# Local Planning Panel

15-17 William Street, Alexandria

D/2020/1059

# SEPP55 - contamination

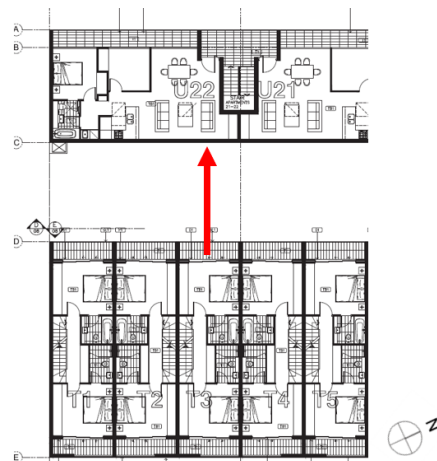
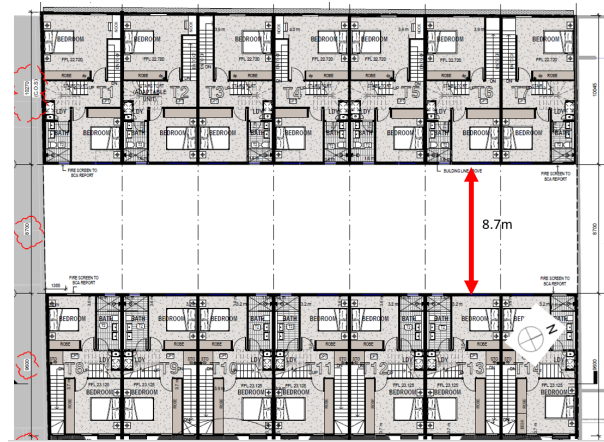
- SEPP55 not been satisfied
- applicant has failed to demonstrate site can be made suitable for residential use
- contamination statement not been reviewed by a Site Auditor

# landscaping

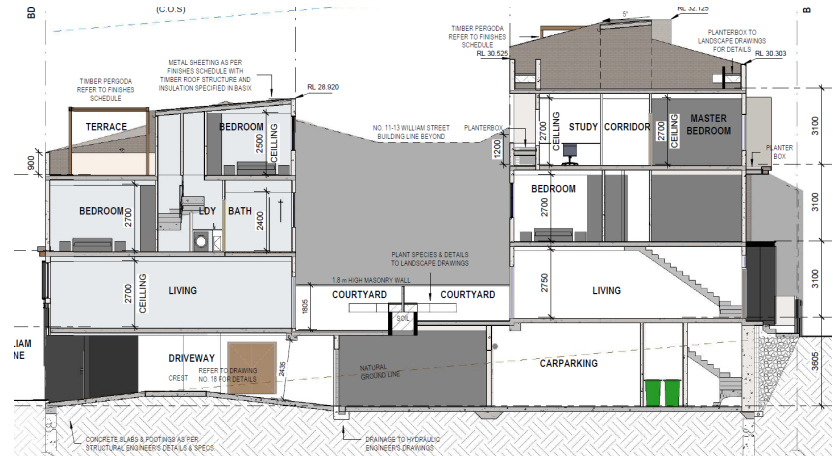
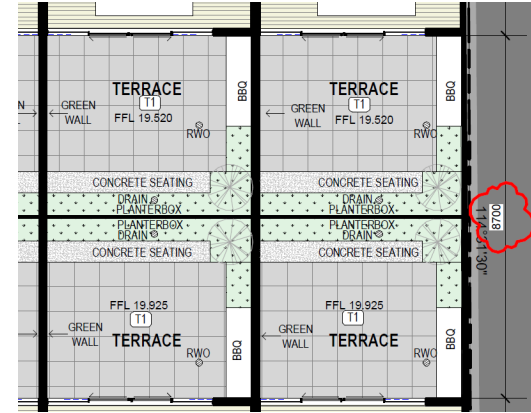
- only 5.5% inadequate site area deep soil - William Street frontage (15% required)
- planter boxes in central courtyard inadequate for substantial planting
